# Th 8a

STAFF REPORT: REGULAR CALENDAR

1-98-58

Repair and expand a riprap revetment.

# SITE PLAN of FURMANSKI PROPERTY Showing 1991 Rip Rap and New Fill Princeton by the Sea

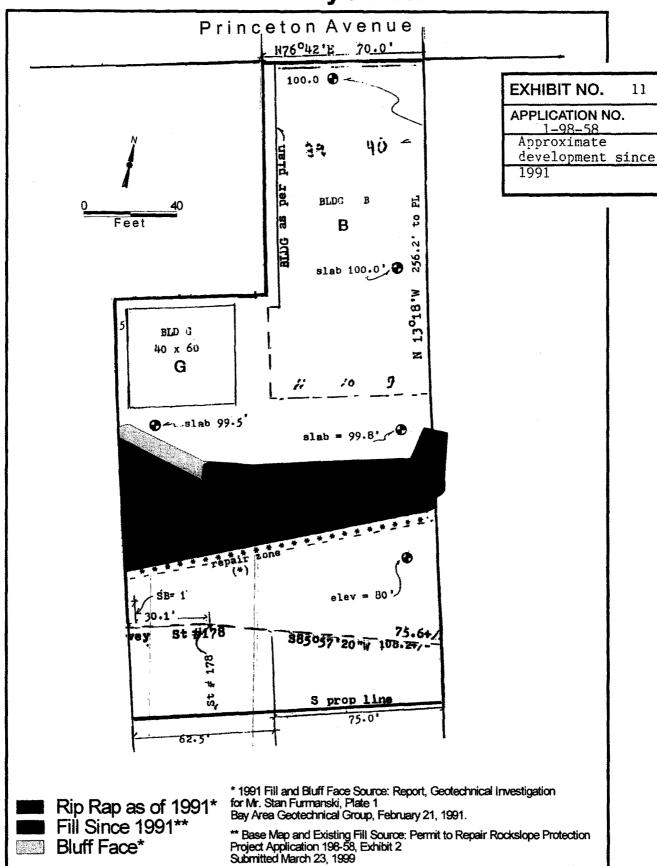
- (e) The property boundaries for this site need to be clarified.
- (f) Regarding the additions to the structure proposed in your new application, your Attachment #3 shows the new "revetment" addition located just inside the Assessor's Parcel line. You also show permanent backfill behind the retaining wall up to grade at the top of the wall. In your Attachments #6 and #26 you show the "proposed revetment" and "existing rip rap" north (landward) of the "revetment." You do not show any seawall materials south (seaward) of the "revetment" in any of these figures.

Please clarify if your application includes removing any fill materials that, as shown in your Attachment #3 and observed in our field visits, lie seaward of the

proposed location of the retaining wall, and submit revised plans, if necessary, to show all the work for which you are seeking authorization.

Station 178 has elev of 77'. Top el: TOR=100'
- 2 (e) The boundaries are shown on Plan 2. (Bluebinder "B") Five Supreme Court cases support boundaries
- 2 (f) The primary repair is Exhibit #1, #2, of blue binder, involves no revetment. As alternatives, three revetments are proposed: Blue Binder Exhibits #40, #41, #42. No rip-rap is required South of the concrete, but placing rip-rap there would reduce the chance of scour (but is not required structurally)
- The lower wall has mainly 24-60" diam bolders, and upper wall 16-24" diam bolders, of excellent quality. The good quality stone is verified by an engineering consultation from a shoreline specialist (Ex #5). The specialist has proposed the "proposed repair", Exhibit #1, in Bluebinder.
